Southern Nevada Amendments to the 2024 International Fire Code

Including various NFPA Standards

SNFC / FPAN International Fire Code Committee

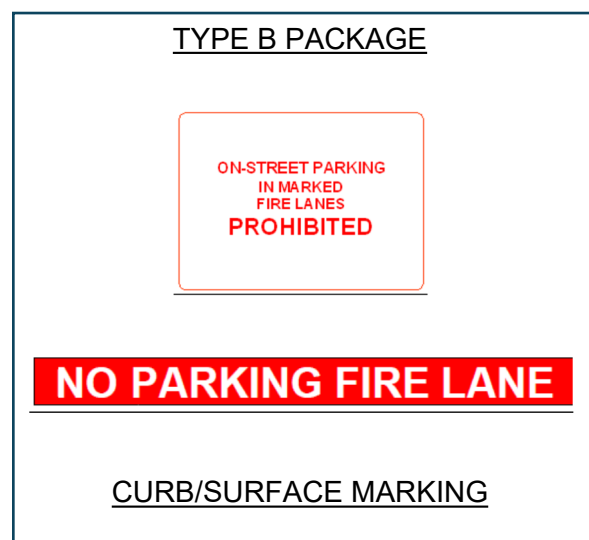
Type A Package: Marking shall consist of painting the curb, or street surface, where no curb is present, with a suitable coat of industrial red enamel along the entire fire apparatus access lane where parking or obstructions are prohibited. All curb that is painted red shall also be marked by signage stating “NO PARKING FIRE LANE”(Type A package). Signs are to be installed no higher than 10 feet or less than 6 feet from the surface of the roadway. Signs shall be located at each end of painted curb, and additionally in between so that the maximum separation between signs is 100 feet, as measured along the centerline of the fire apparatus access road.

Type B Package: Minimum of one sign is provided at every entrance stating “ON-STREET PARKING IN MARKED FIRE LANES PROHIBITED” (Type B package), fire lanes shall be marked by painting the words “NO PARKING FIRE LANE” (Curb/surface marking), over the face of the red-painted curbs or street surface where no curbs are present. The words on the curbs shall be painted in white letters not less than 4 inches in height with a brush stroke of not less than ¾ inch. The maximum separation between markings shall be 50 feet, as measured along the centerline of the fire apparatus access lane.

JUSTIFICATION: This amendment is intended to provide consistency for regional application of codes. The purpose of this amendment is to specify requirements for marking of fire access lanes where obstructions are prohibited, also in accordance with state law. The proposal requires that red-painted curbs be provided along the areas where obstructions are prohibited. The proposal provides an option for fire lane signage, and for stenciling fire lane wording on the curb.
